Grimes Planning and Zoning Commission Agenda

Grimes Tree Farm Expansion

RE: Grimes Tree Farm Expansion Site Plan Amendment

The Development Services Department is in receipt of a proposed Site Plan Amendment for the Grimes Tree Farm Expansion. Based on the review of the provided submittal materials, staff have the following comments:

Sheet 3.0

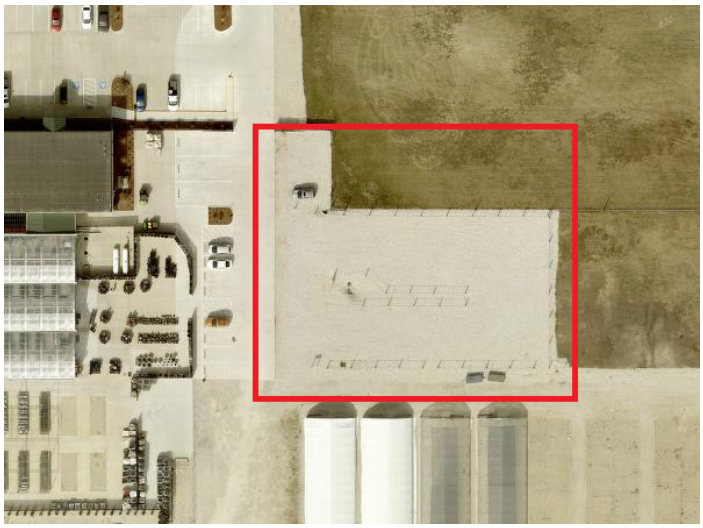
1. What is GP referring to? There is a note to protect the post but what are the posts for? Why are they in the detention area? This area was changed to gravel since the previous site plan was approved in 2022. Gravel is not permitted. This area will need to be changed back to grass or paved. If removed, please show removal on the site plan. If paved, please show the paving details on the site plan and update the SWMP accordingly.
